MEMORANDUM **Transportation & Development – PZ Memo No. 12-100**

SUBJECT: ZUP12-0028 PRESIDIO WIRELESS FACILITY

Request: Use Permit approval to install a 65'-high (62' top of antennas) monopalm wireless communication facility.

DETAILED PLAN

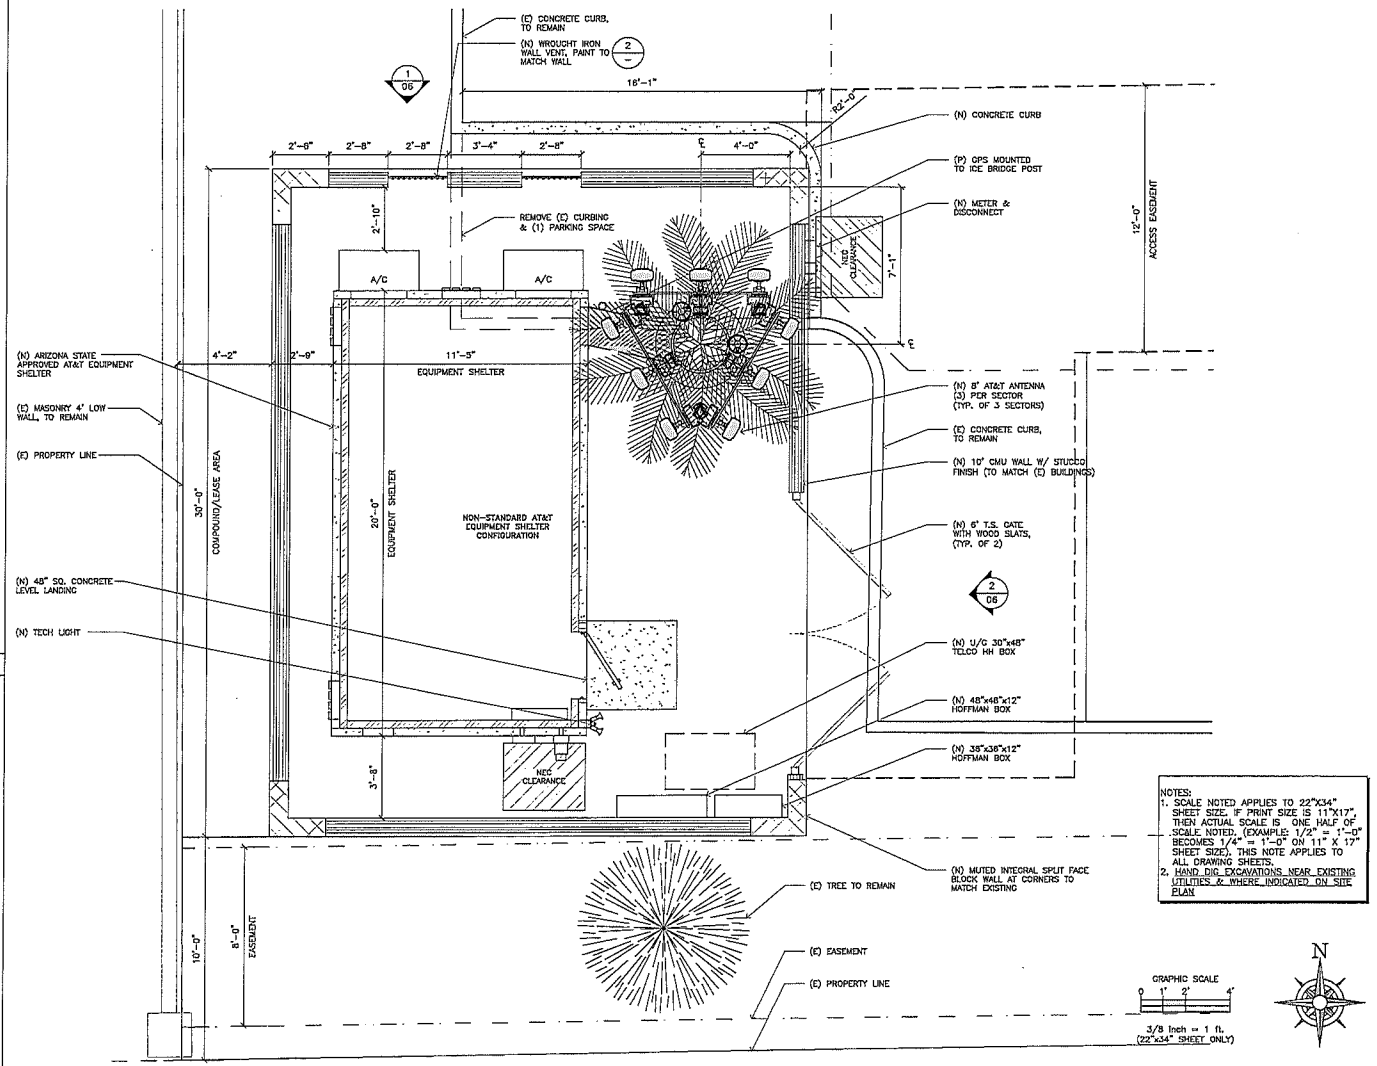
3. Further screening shall be required along with the wrought iron fencing to visually conceal the equipment inside.

TOWER ELEVATIONS

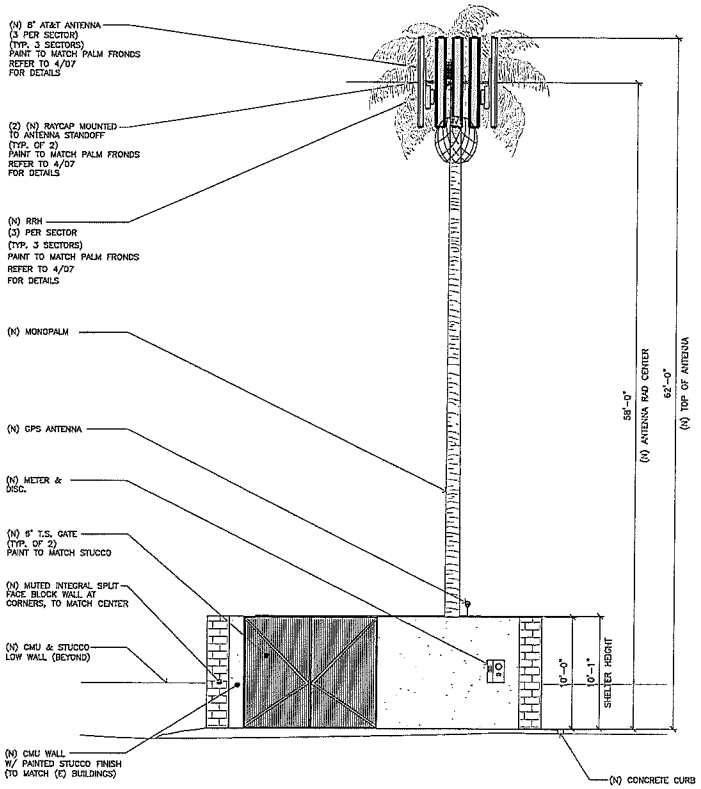
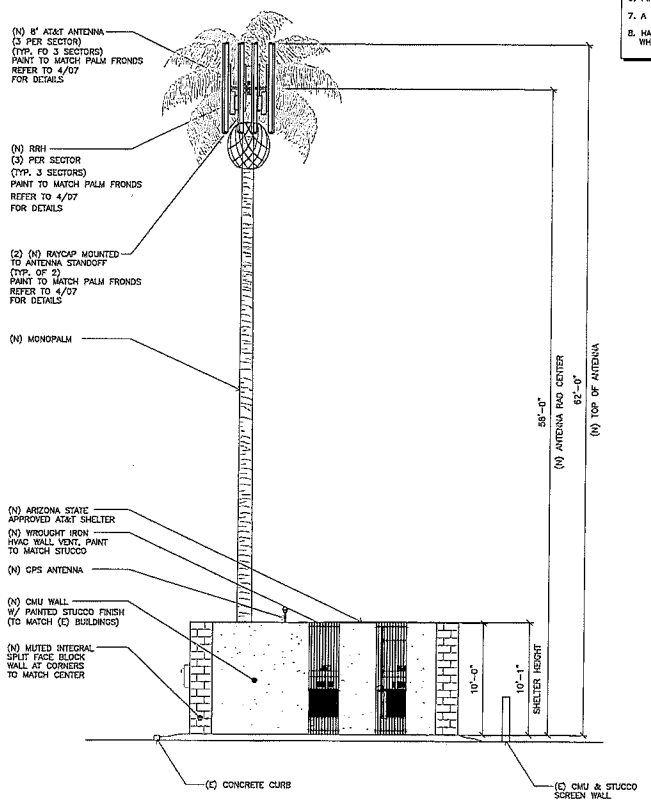
Staff recommends that the monopalm fronds be required to extend beyond the antennas and additional opaque screening be added to the wrought iron fencing surrounding the ground equipment to ensure adequate camouflage. The applicant has brought the antenna arrays as close to the pole as possible and any needed extension of frond length is not anticipated to present an unnatural appearance.

2. The monopalm shall provide long enough palm fronds so as to extend beyond the antennas to provide adequate camouflage.
